REPORT AMENDED BY STAFF 11-12-87
CITY PLANNING COMMISSION

- APPLICATION:
- A. Negative Declaration
 - B. Rezone 1+ vacant acre from Standard Single Family (R-1) to Multi-Family (R-2B; 2,000 sq. ft. unit)
 - C. Tentative Map (P87-341)
 - D. Special Permit to develop 21 apartment units on four lots and a common lot in the R-2B zone.

LOCATION: 2840 Taft Street

APPLC. NO. P87-341 MEETING DATE October 8, 1987 ITEM NO 6

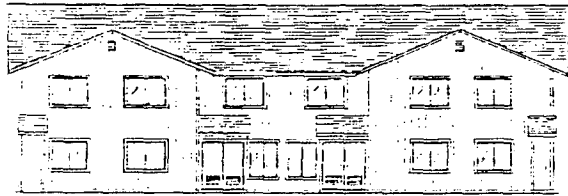
There are two different elevations for the six unit structures. One unit has two front gables and the other has one front gable. Staff suggests that more interest would be provided if the two-gable structure were used twice, therefore, the end building, units 13 through 18, should be of the double gable elevation as well as the front building units, 1 through 6.

End elevations have small paned windows. This treatment should be carried to the front elevations.

Staff also suggests that front roof overhangs be extended flush with the outside of the stairway for both elevations.

1. The double-gable elevations shall be used for units 1-6 and 13-18.
2. Roofing material shall be shake shingles.
3. The roof overhang for the front elevations shall extend out flush with the stairway handrail.

4. Stairways, handrails and verticals shall be of wood.
5. Stairways shall be double-stringer.
6. Small paned windows shall be used on the front and end elevations.

REAR ELEVATION UNITS 1 THRU 6

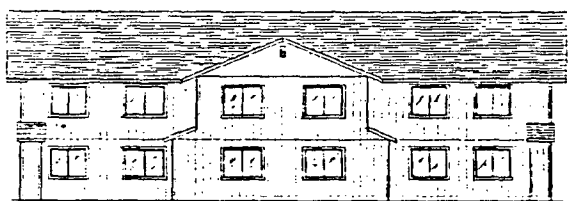
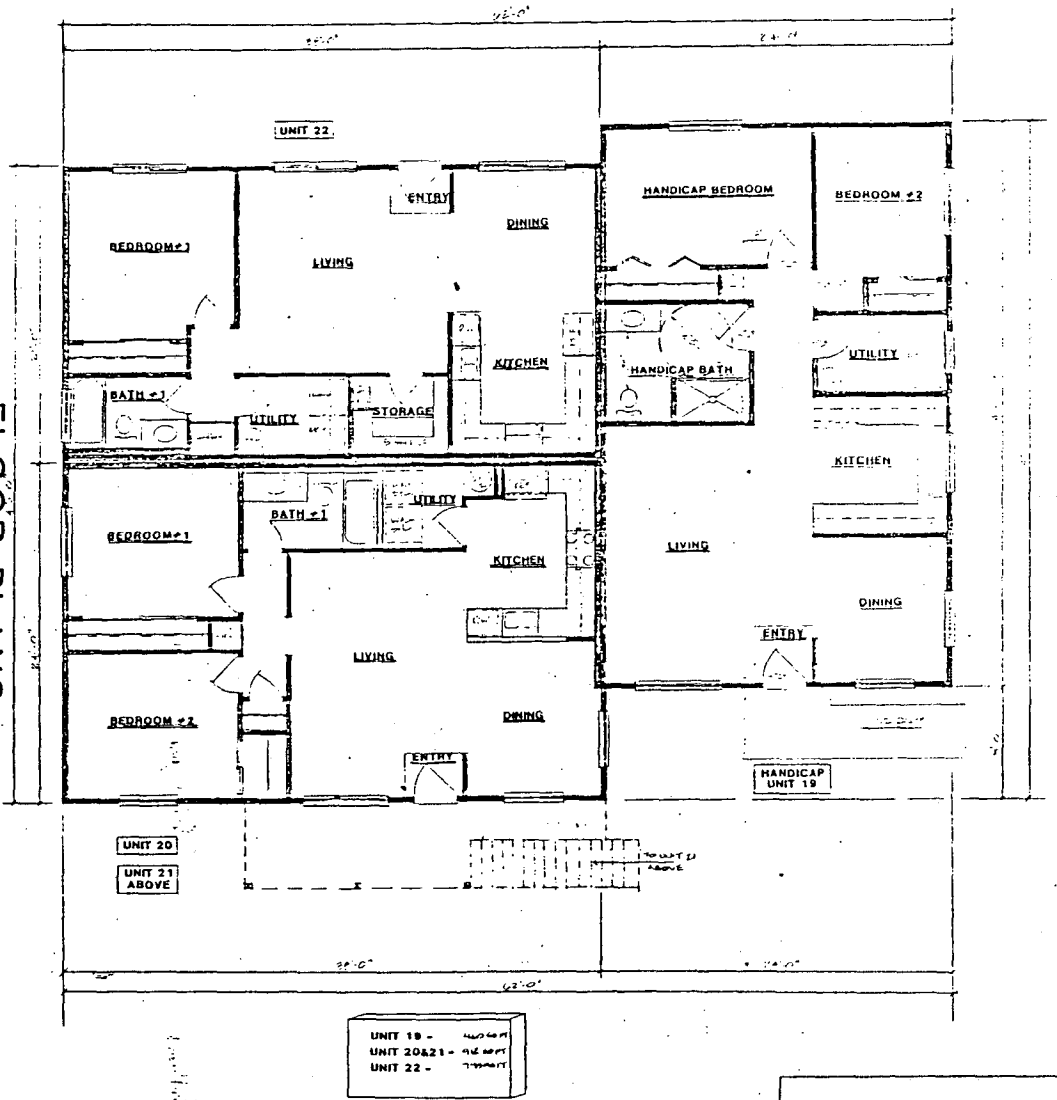
To break up the rear elevation, staff suggests trees be planted along the northern property line. Detailed landscaping and irrigation plans shall be approved by staff prior to issuance of building permits.

7. Detailed landscaping and irrigation plans shall be approved by staff prior to issuance of building permits; these plans shall include trees planted along the north property line to soften the appearance of the rear elevation.
